UNITED STATES PATENT AND TRADEMARK OFFICE

APPLICATION NO.	FILING DATE	FIRST NAMED INVENTOR	ATTORNEY DOCKET NO.	CONFIRMATION NO.
10/802,344	03/17/2004	William L. Walburn	10938/004	3642

Office Action Summary	Application No.		Applicant(s)	
	10/802,344		WALBURN, WILLIAM L.	
	Examiner		Art Unit	
	Philip Gabler		3637

DETAILED ACTION

Schreyer '761 Figures 2 and 3

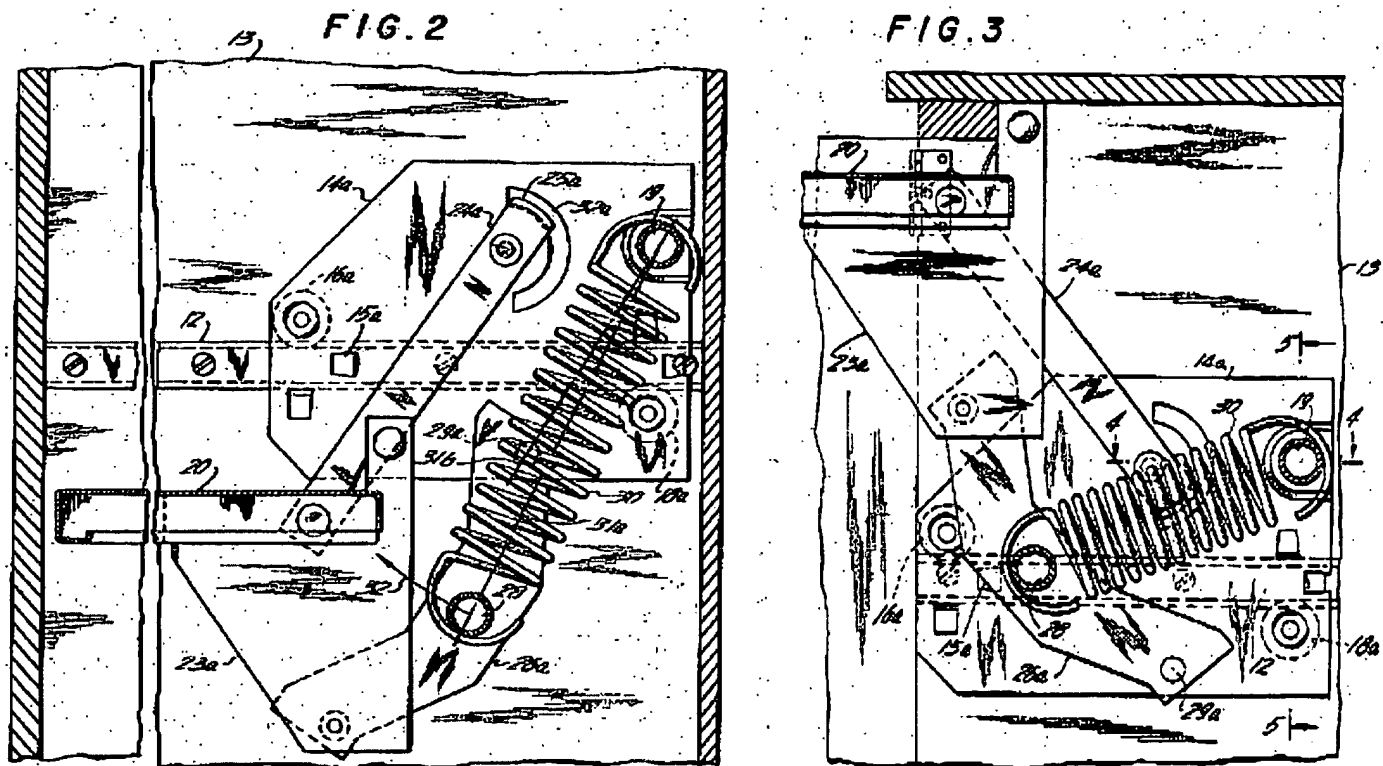
5. Claims 1-6 are rejected under 35 U.S.C. 102(b) as being anticipated by Schreyer (US Patent Number 3425761). Schreyer (Figures 2 and 3) discloses a shelf lift system comprising: a support bracket (14a), a first (upper pivot of arm 24a) and second (29a) pivot coupled to the bracket, first (24a) and second (26a) bars respectively coupled to the first and second pivots for movement relative to the support bracket, a shelf support (23a) coupled to the first and second bars for movement with the bars relative to the bracket between an upper and a lower position (see Figures 2 and 3), one of the first and second bars including a stop contact portion (25a), and a slot (32a) which is functionally equivalent to a cushion, wherein slot (32a) is formed on the support bracket at a position to intercept the bar stop contact portion when the shelf support moves to the lower position.

6. Regarding claim 2, Schreyer further discloses the cushioning slot (32a) is fixed between the first and second pivots.

7. Regarding claim 3, Schreyer further discloses the stop contact portion (25a) comprises an end portion of one of the bars (24a) extending from one of the first and second pivots away from the shelf support (23a).

8. Regarding claim 4, Schreyer further discloses a biasing member (30) having a first end coupled to the support bracket (via rod 19) and a second end coupled to one of the first and second bars (via rod 28) applying a force there between, said cushioning slot (32a) being generally situated along a line between the first and second ends of the biasing member when the shelf support is in the upper position (see Figure 3).

9. Regarding claim 5, Schreyer further discloses the first and second ends of the biasing member are situated in an over-center relationship with respect to at least one of the first and second pivots when the shelf support is moved to the lower position, so that the bar stop contact portion is biased into contact with the cushioning slot (see Figure 2 and column 3 lines 5-26).

10. Regarding claim 6, Schreyer further discloses a tension adjustment member (28) coupled to the biasing member for adjusting the force applied by the biasing member. [Translation of member 28 during rotation of member 26a will alter the length of biasing member 30 and accordingly adjust the force applied by the member.]

Fetch '305 Figures 1 and 2

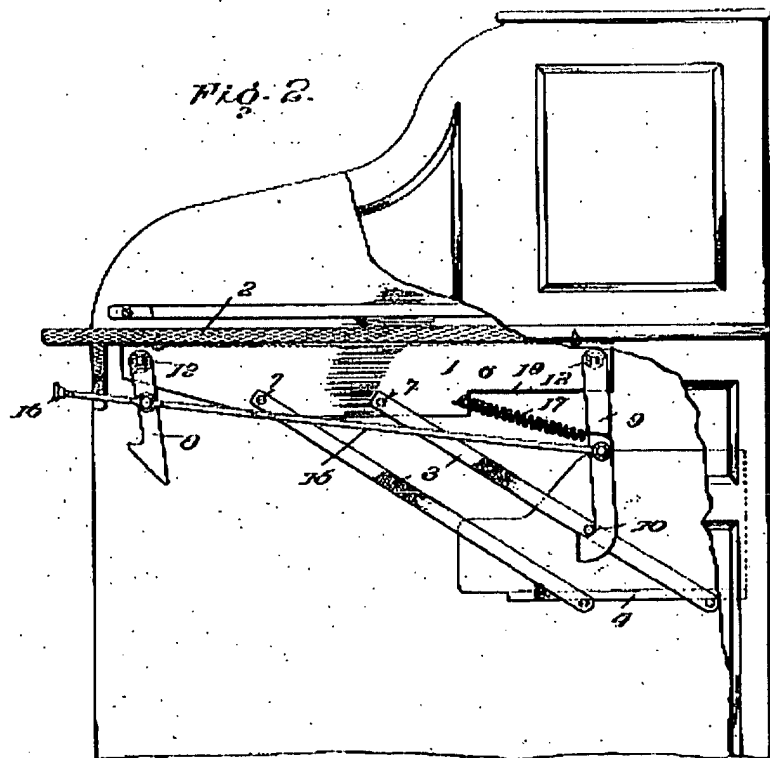
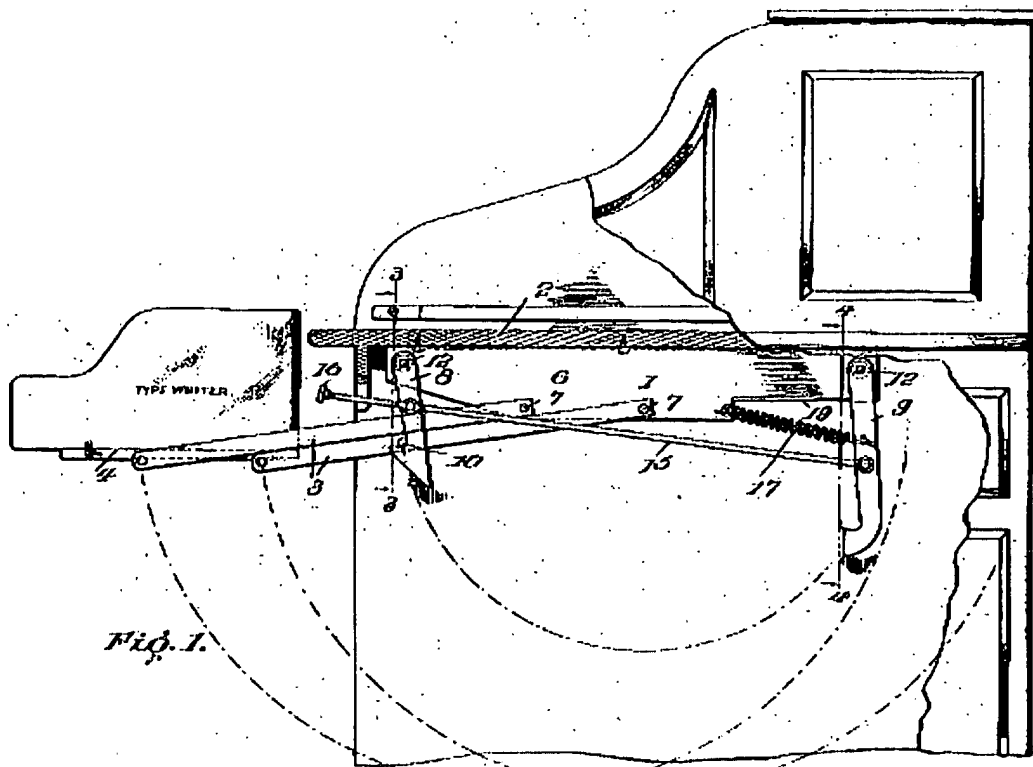
11. Claims 1 and 8-10 are rejected under 35 U.S.C. 102(b) as being anticipated by Fetch (US Patent Number 883305). Fetch (Figures 1 and 2) discloses a shelf lift system comprising: a support bracket (6), a first and second pivot (both labeled 7) coupled to the bracket, first and second bars (both labeled 3) respectively coupled to the first and second pivots for movement relative to the support bracket, a shelf support (4) coupled to the first and second bars for movement with the bars relative to the bracket between an upper and a lower position (see Figures 1 and 2), one of the first and second bars including a stop contact portion (10 and surrounding section of bar),

and a cushion (9) fixed to the support bracket at a position to intercept the bar stop contact portion when the shelf support moves to the lower position.

12. Regarding claim 8, Fetch further discloses a latch (8) coupled to the shelf support (indirectly, via the linkage) and a latch pin (10) coupled to one of the first and second bars at a position that permits engagement of the latch pin and latch when the shelf support is in the upper position (see Figure 1).

13. Regarding claim 9, Fetch further discloses a latch release lever (15) coupled to the latch to facilitate the release of the latch from the latch pin, and a latch biasing member (17) coupled to the latch (through members 9 and 15) to bias the latch toward engagement with the latch pin.

14. Regarding claim 10, Fetch further discloses lever mounting pins (attachment points of lever 15 to members 8 and 9) for movably mounting the latch release lever to the shelf support (indirectly, via the linkage), the lever including a handle (16) facilitating the movement of the latch release lever and latch relative to the shelf support.

Exhibit 1: Schneller '623 Figures 8 and 10

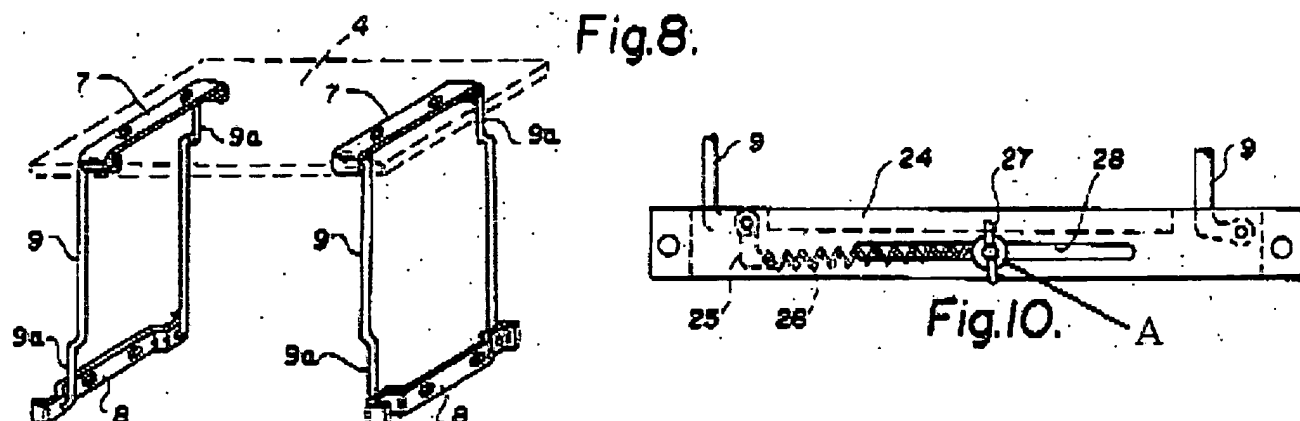
Schreyer discloses a shelf lift system as recited in claim 6 but does not disclose a tension adjustment plate. Schneller (Figures 8 and 10) discloses a shelf lift system (Figure 8) including a tension adjustment plate (washer or flange labeled A in Exhibit 1, which is functionally equivalent to a tension adjustment plate) coupled to a biasing member (26) to permit changes in length of the biasing member (the assembly of Figure 10 replacing component 8 of Figure 8 – see column 3 lines 42-51). Accordingly, it would have been obvious to one of ordinary skill in the art at the time the invention was made to modify Schreyer's lift system to include a tension adjustment plate as taught by Schneller because this arrangement would allow fine tuning of the lifting and lowering assistance provided by the system.

upper and a lower position (see Figures 2 and 3), and a biasing member (30) having a first end coupled to the support bracket (via rod 19) and a second end. Schreyer does not disclose a tension adjustment plate. Schneller (Figures 8 and 10) discloses a shelf lift system (Figure 8) including a tension adjustment plate (washer or flange labeled A in Exhibit 1, which is functionally equivalent to a tension adjustment plate) coupled to a biasing member (26) and pivotally coupled to a component (24) of a shelf lift system for movement relative to a support bracket (also 24) to provide adjustable biasing force, and a fastener (27) for securing the tension adjustment plate. Accordingly, it would have been obvious to one of ordinary skill in the art at the time the invention was made to modify Schreyer's lift system to include a tension adjustment plate as taught by Schneller because this arrangement would allow fine tuning of the lifting and lowering assistance provided by the system.

Schneller (Figures 8 and 10) discloses a shelf lift system (Figure 8) including a tension adjustment plate (washer or flange labeled A in Exhibit 1, which is functionally equivalent to a tension adjustment plate) coupled to an end of a biasing member (26) and pivotally coupled to a bar (9 through element 25), and a fastener (27) for securing the tension adjustment plate at a selected position to provide a biasing force to aid in movement of a shelf (4). Accordingly, it would have been obvious to one of ordinary skill in the art at the time the invention was made to modify Koch's lift system to include a tension adjustment plate as taught by Schneller because this arrangement would allow fine tuning of the lifting and lowering assistance provided by the system.

Exhibit 2: Koch '075 Figures 1-3

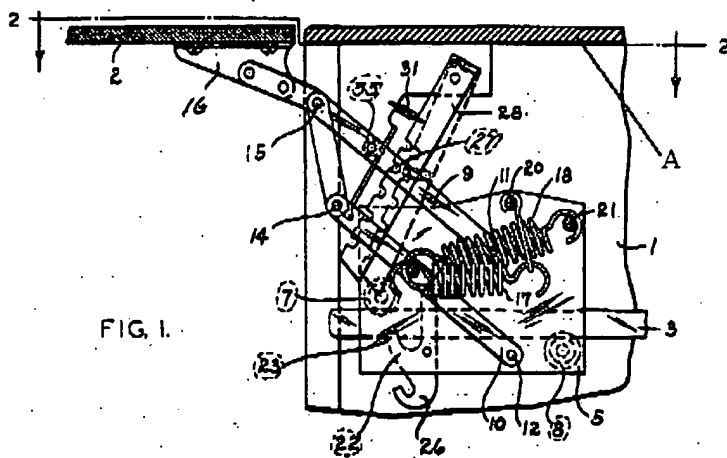
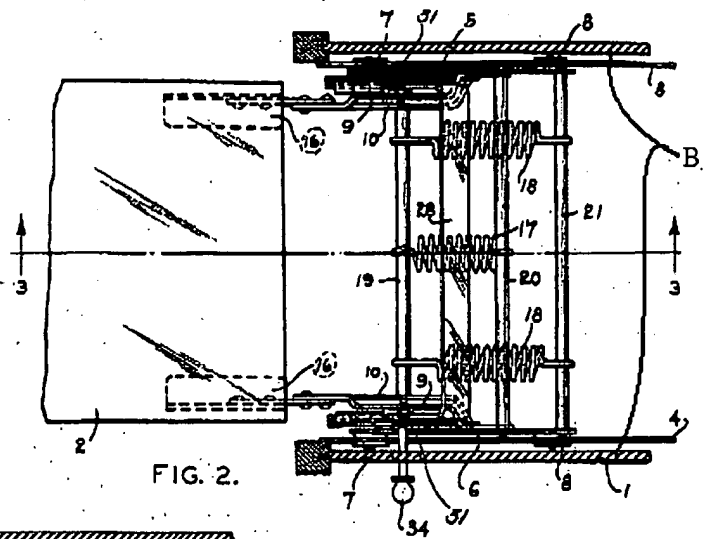
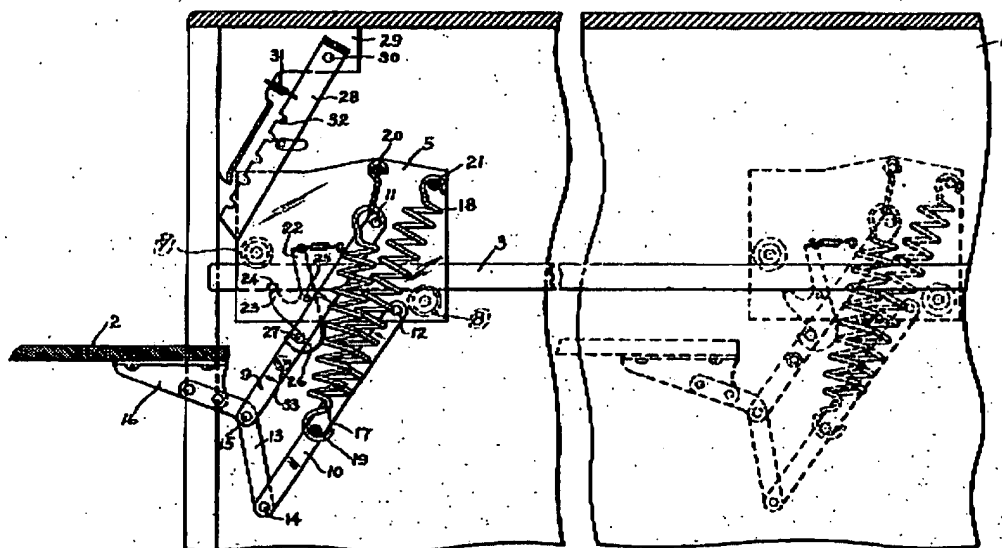
23. Claim 17 is rejected under 35 U.S.C. 103(a) as being unpatentable over Koch (US Patent Number 2541075) in view of Schneller. Koch (Figures 1-3) discloses a shelf lift system for use in a cabinet (1) having a top surface (viewed as A in Exhibit 2) and a pair of sidewalls (B) defining a space below the top surface, the shelf lift system comprising a pair of support brackets (5 and 6), each bracket having a mounting surface to be fixed to one of the sidewalls (via tracks 3 and 4), a first and second pivot (11 and 12) coupled to each bracket, a swingable linkage including first and second bars (9 and 10) respectively coupled to the first and second pivots of each bracket for movement relative to each support bracket, shelf supports (16) coupled to each of the first and second bars (via member 13) and supporting a common shelf (2) for movement of the shelf with the bars relative to the brackets between an upper position wherein a shelf (2) is situated generally coplanar with the cabinet top surface (see Figure 1) and a lower position wherein the shelf is situated fully within the cabinet below the top surface (see Figure 3), biasing members (18) having first ends coupled to one of the support brackets (via 21) and second ends, latches (28) coupled (indirectly) to the shelf supports and latch pins (27) coupled to one of the first and second bars at a position permitting engagement of the latch pin and latch when the shelf is in the upper position (see Figure 1), a latch release lever (34) coupled to the latch to facilitate release of each

latch from any engaged latch pin to allow the shelf to move to the lower position, and cushions (26) fixed to each support bracket at a position to intercept a stop contact portion (27 and surrounding section of bar) of one of the bars when the shelf support moves to the lower position. Koch does not disclose a tension adjustment plate.
